From: John Long
Sent: 18 July 2022 09:21
To: Hilary Saunders <h.saunders@northyorkmoors.org.uk>
Subject: Response to NE letter - Klagester

Project **SNOWDON NAB BARN
EGTON GRANGE
WHITBY, YO22 5BA**

Drawing **SITE PLAN WITH DRAINAGE FIELD
DETAILS**

Planning consultation: Conversion of outbuilding to a principal residence dwelling with associated amenity spaces, landscaping, package treatment plant and parking.

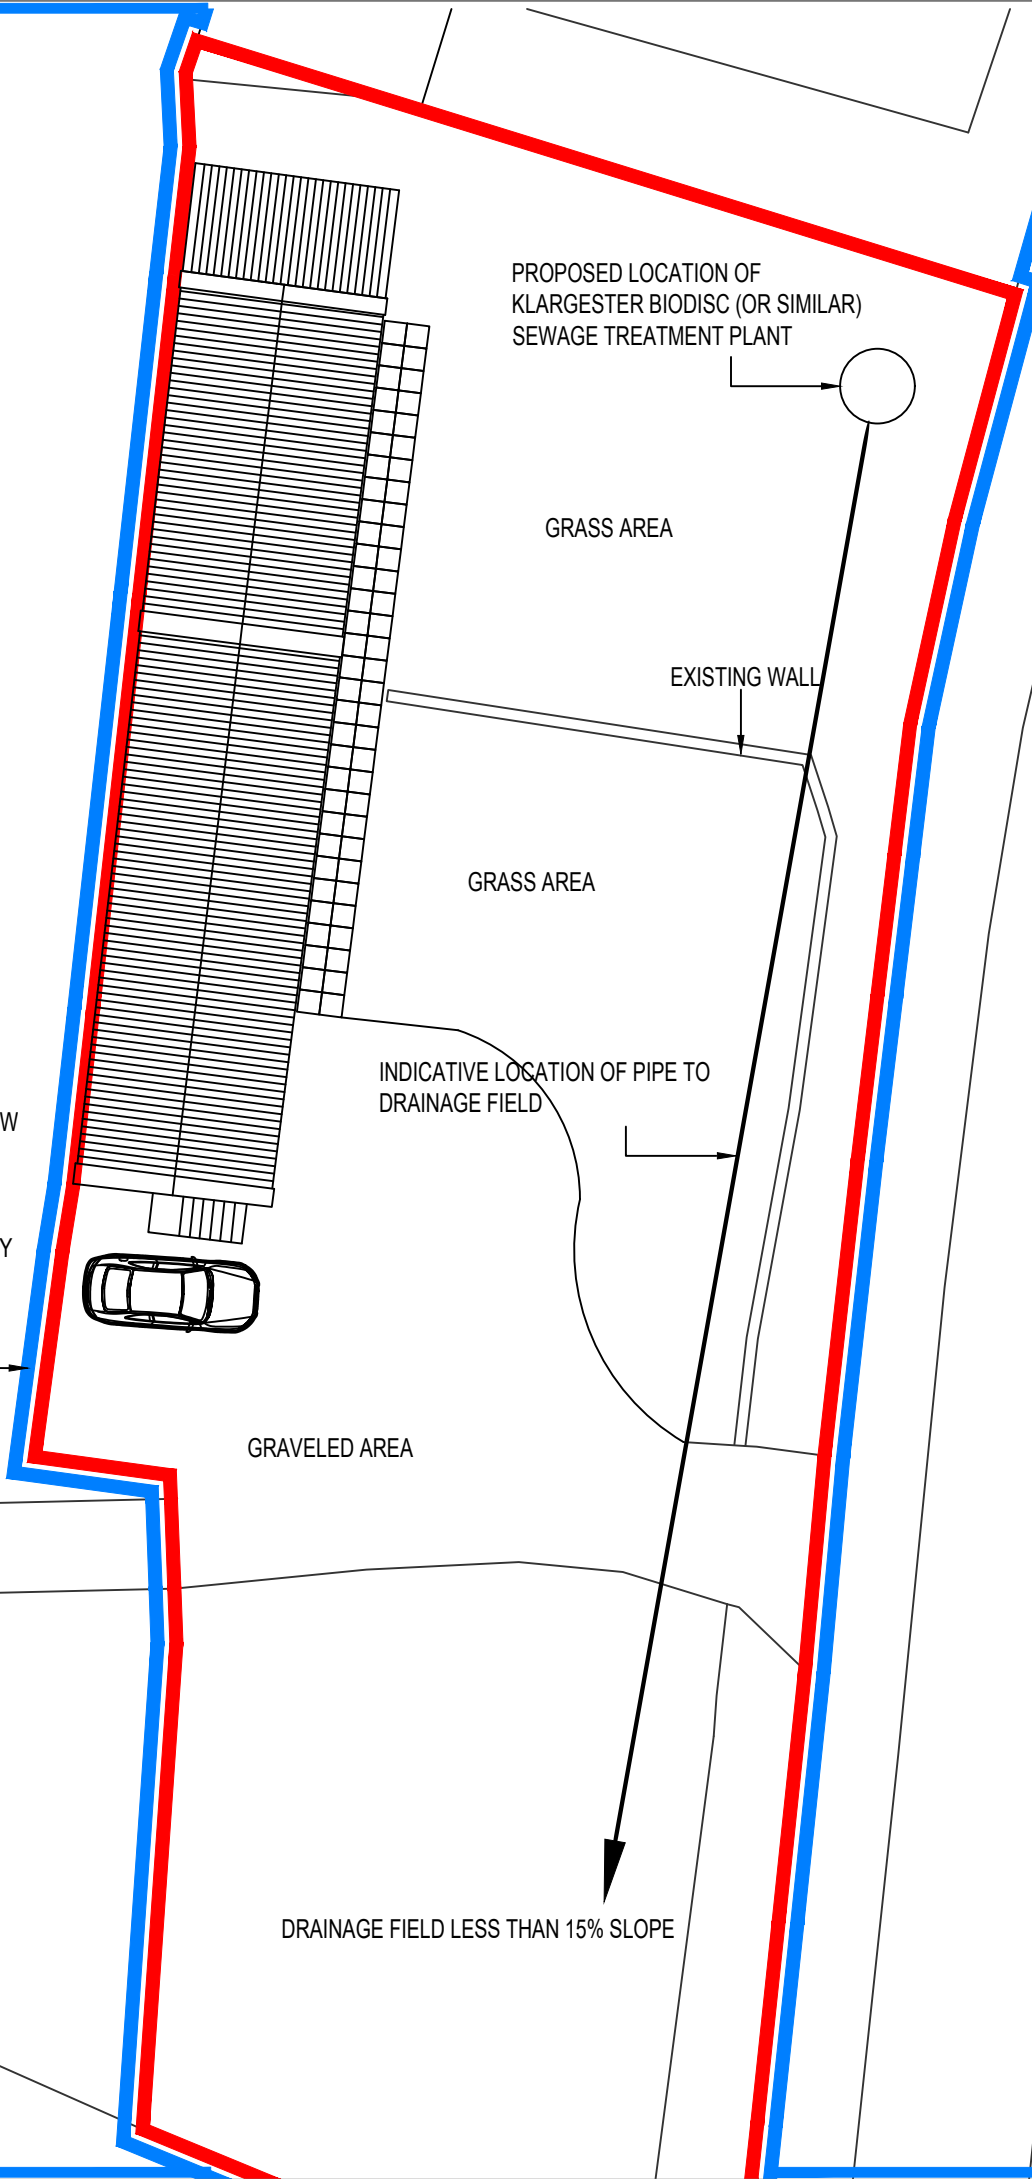
As submitted, the application could have potential significant effects on Arncliffe and Park Hole Woods SAC/SSSI. Natural England requires further information in order to determine the significance of these impacts and the scope for mitigation.

- *Habitats regulations assessment (HRA)*
- *Confirmation of PTPs discharge method (direct to watercourse or drainage field)*

- The Klargester biodisk package treatment plant will be required to discharge either directly to watercourse or to a drainage field. Natural England advise if the proposal is to discharge directly to watercourse then an environment agency permit will be required.

version 4). 6 x 150 litres = **0.9 m3** per day. It is also within the operational capacity of the Klagester bio disc 6 person unit: BA (1.2m3). You can see that the outflow will be significantly below NE's specified rate of 5.0 m3 per day.

The drainage field is more than 50m from the designated site boundary; and more than 40m from any surface water feature; it is in a area with a slope no greater than 15%; where the highwater table depth is at least 2m below the surface at all time; is not subject to significant flooding; and there are no known factors which would expedite the transport of phosphorus for example fissured geology, known sewer flooding, conditions in the soil/geology that would cause remobilisation phosphorus, presence of mineshafts; and there is no information on other discharge to ground within 200m. Nb – the Mulgrave Estate own the surrounding farmland surrounding the property.

PROPOSED LOCATION OF KLARGESTER BIODISC (OR SIMILAR) SEWAGE TREATMENT PLANT

DRAINAGE FIELD LESS THAN 15% SLOPE
